OS-299 (10-22)  pennsylvania DEPARTMENT OF TRANSPORTATION www.penndot.pa.gov	TRANSMITTAL LETTER	PUBLICATION: Publication 148						
		DATE: 4/6/2026						
SUBJECT: Revisions to Traffic Standards – Signals TC-8800 Series December 2011 Edition, Change No. 3								
INFORMATION AND SPECIAL INSTRUCTIONS: Incorporate the attached revisions to the December 2011 Edition of Publication 148. These revised Standard Drawings should be adopted on all new and existing designs as soon as possible without affecting any letting schedules and in conjunction with current Publication 408 Specifications. The standards were updated to include a wood post mounting option for Flashing Warning Devices/Border Lit Signs. Additions, deletions, and revisions specific to each Standard and Sheet are as follows: <table border="1" data-bbox="152 961 1425 1140"> <thead> <tr> <th>STANDARD</th> <th>SHEET</th> <th>DESCRIPTION OF CHANGES</th> </tr> </thead> <tbody> <tr> <td>TC-8808</td> <td>1</td> <td>"FLASHING WARNING DEVICE WOOD POST MOUNTING" Sheet added to standards.</td> </tr> </tbody> </table>			STANDARD	SHEET	DESCRIPTION OF CHANGES	TC-8808	1	"FLASHING WARNING DEVICE WOOD POST MOUNTING" Sheet added to standards.

**CAST IRON OR STEEL
JUNCTION BOX, TYPE JB-26
OR TYPE JB-27**

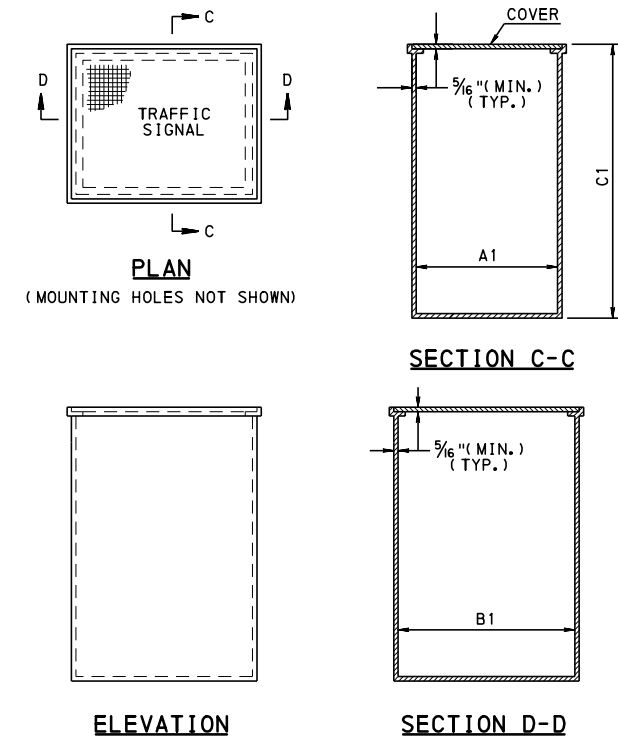
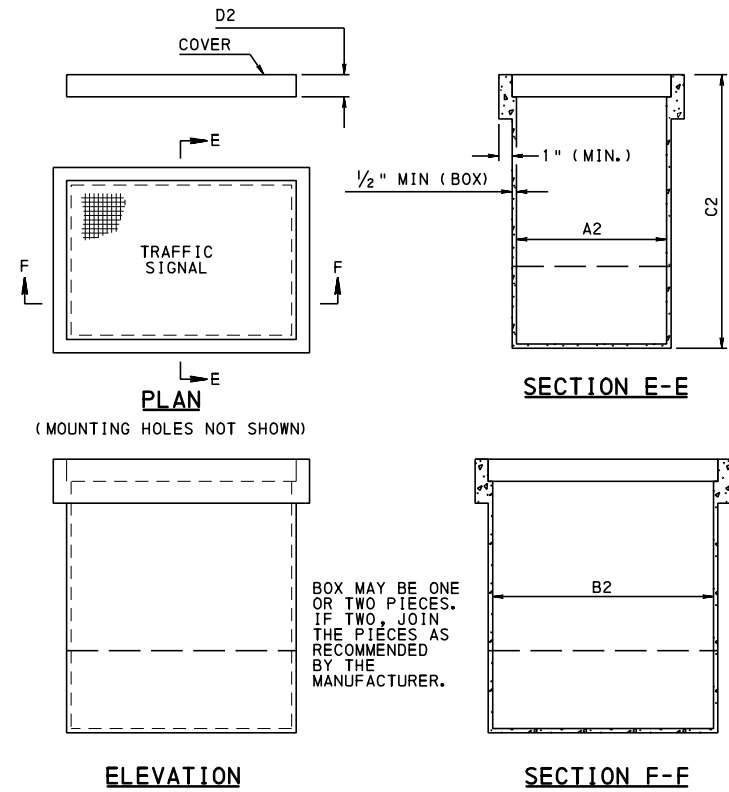
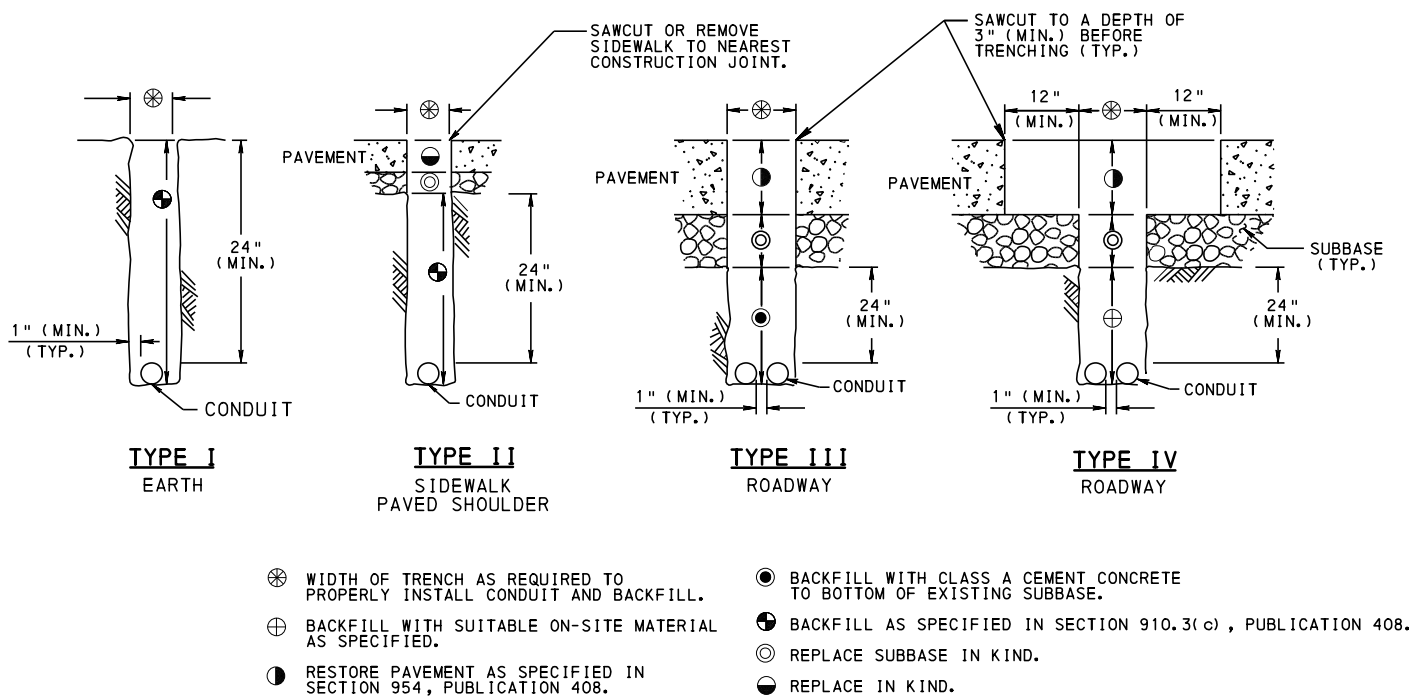
TC-8804	2	Updated Junction Box, Type JB-26 and Junction Box, Type JB-27 Details as follows: -Revised Junction Box Details to a typical detail for cast iron or steel and a typical detail for reinforced plastic mortar or high-density polymer concrete with dimensions for each detail labeled as variables. Identified corresponding required JB-26 and JB-27 dimensions in tabular format. Added JB-30 dimensions to table as applicable. Updated Typical Junction Box Installation Junction Box in Paved Surface Detail as follows: -Revised label of detail from ‘JUNCTION BOX IN PAVED SURFACE’ to “JUNCTION BOX IN PAVED SURFACE AND SIDEWALK” Updated Trench and Backfill Detail as follows: -Revised fifth symbol note from “BACKFILL AS SPECIFIED IN SECTION 954, PUBLICATION 408” to “BACKFILL AS SPECIFIED IN SECTION 910.3 (c), PUBLICATION 408” Updated Notes as follows: Revised the first sentence of Note 2 from “JUNCTION BOXES – USE JB-26 AND JB-27 ONLY IN AREAS NOT SUBJECT

TO VEHICULAR TRAFFIC.” to “JUNCTION BOXES – USE JB-26, JB-27 AND JB-30 ONLY IN AREAS NOT SUBJECT TO VEHICULAR TRAFFIC ”	
TC-8805	1	Updated Visor Types for Vehicular Signal Head Details as follows: -Removed Full-Circle Visor Detail -Added Dimension B to show visor lengths in lieu of describing in a note -Added a visor dimension table^o for visor dimensions A and B -Revised detail note from “THE VISOR SHALL BE A MINIMUM OF 9.5” FOR A 12” SIGNAL LENS AND 7” FOR AN 8” SIGNAL LENS WITH A DOWNWARD TILT OF 3.5 DEGREES” to “THE VISOR SHALL HAVE A DOWNWARD TILT OF AT LEAST 3^o ” Updated Backplate for Vehicular Signal Head Detail as follows: - Revised “5” MIN” callouts to “5” - 8”.”. - Revised Backplate detail to show reflective yellow border and added callout “2” MIN. FLOURESCENT YELLOW RETROREFLECTIVE BORDER” - Added note below detail label which reads “*BACKPLATE CONFORMING TO PUBLICATION 408 SECTION 955.2 (B) 3 SHALL BE ONE PIECE ALUMINUM” Updated Pedestrian Signal Head Detail as Follows: -Corrected spelling of word “SHOULD” in bottom note
